SUBJECT: Margin of Seismic Safety for Postulated Seismic Events

Actinide Packaging and Storage Facility (APSF) Seismic Verification Study

APSF Seismic Verification Study Spectrum

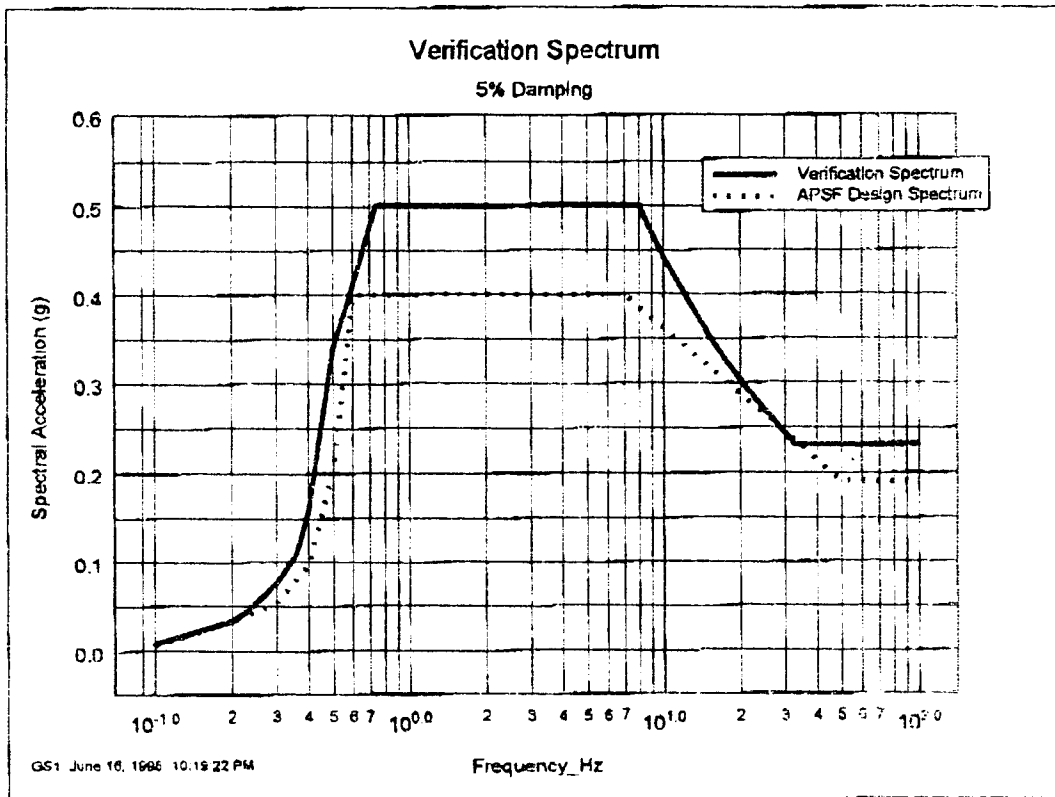
1. *The attached spectrum be used to check or challenge the APSF design and generate floor response spectra.*

The discussions between the DNFSB staff and SRS personnel on Thursday, June 11, 1998, indicated that the focus on using a verification spectrum was primarily for determining the conservatism in the APSF design, particularly with respect to in-structure vertical response spectra. Subsequent comments from the DNFSB suggest that for completeness, the spectra in the horizontal direction also be evaluated. The Verification Spectrum is the starting point to establish the extent to which seismic margin exists relative to the applicable codes and standards.

SRS will use the DNFSB Verification Spectrum to generate in-structure horizontal and vertical response spectra at the roof elevation of the Auxiliary Building and the roof elevation of the MAA building. The use of this spectrum will require that statistically independent time histories be developed with spectra compatible to the Verification Spectrum. These time histories will be applied to the elevations of the basemat of the structures.
